Access Compliance Report Public Rights-of-Way (Curb Ramps)

Main Street: CLYDESDALE_DR Cross Street: TALBOTT_CT Location: E

ADA ID: RPRK211112121449 Ramp Type: Type 4 - Parallel Initial Pass/Fail: Pass Overall Compliance: No Severity Score: 25

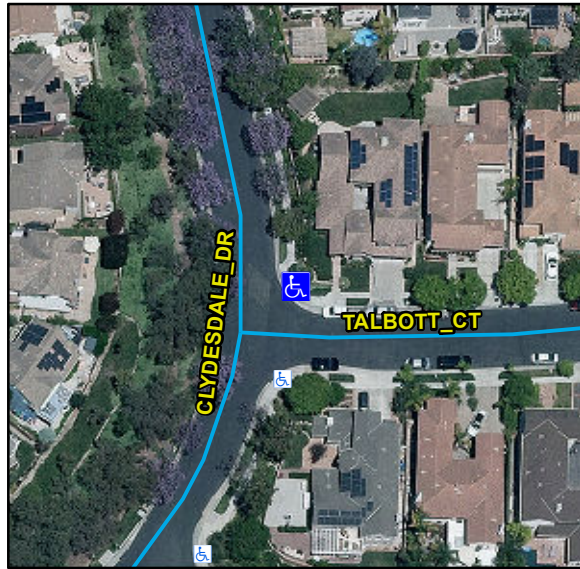
Compliance	Description	Data	Compliance	Description	Data
N/A	Ramp Length LT (in)	124	N/A	Ramp Length RT (in)	132
Yes	Ramp Width LT (in)	54	Yes	Ramp Width RT (in)	54
Yes	Ramp Run Slope LT (%)	7.7	Yes	Ramp Run Slope RT (%)	3.5
Yes	Ramp Cross Slope LT (%)	0.5	Yes	Ramp Cross Slope RT (%)	1.1
N/A	Landing Present	No	No	DWS Provided	No
N/A	Landing Length (in)	N/A	N/A	DWS Contrast	N/A
No	Landing Width (in)	N/A	N/A	DWS Length (in)	N/A
No	Landing Run Slope (%)	N/A	N/A	DWS Full Width	N/A
No	Landing Cross Slope (%)	N/A		DWS Offset Type	N/A
N/A	Landing Movement Obstructed?	No	N/A	DWS Offset Left (in)	N/A
	Landing Movement Type	Curb	N/A	DWS Offset Right (in)	N/A
N/A	Landing Shared	N/A			
N/A	Clear Space	Yes			
N/A	Clear Space To Crosswalk (in)	48			
N/A	Marked Crosswalk 1	No	N/A	Marked Crosswalk 2	No
	Crossing 1 Direction	NW		Crossing 2 Direction	SW
N/A	Marked Crosswalk 1 Width (in)	N/A		Marked Crosswalk 2 Width (in)	N/A

N/A	Ramp Inside Crosswalk 1	N/A	N/A	Ramp Inside Crosswalk 2	N/A
	Crossing 1 Slope (%)	1.1		Crossing 2 Slope (%)	0.5
	Crossing 1 Cross Slope (%)	3		Crossing 2 Cross Slope (%)	0.9
Yes	Gutter Ponding	No	No	Curb Slope	11.4
Yes	Gutter Lip Height (in)	0		Road Run Slope (%)	0.3
No	Gutter Run Slope (%)	6.9		Road Cross Slope (%)	4.2
Yes	Gutter Cross Slope (%)	1.2	No	Perpendicular Joint Present	No
Yes	Overall Surface Condition	Acceptable			
	Cross Gutter Present?	No		Spandrel Present?	No
	Replace Cross Gutter?	N/A		Replace Spandrel?	N/A

Remove & Replace Curb Ramp With Two New Directional Ramps or Equivalent. Remove & Replace Gutter.
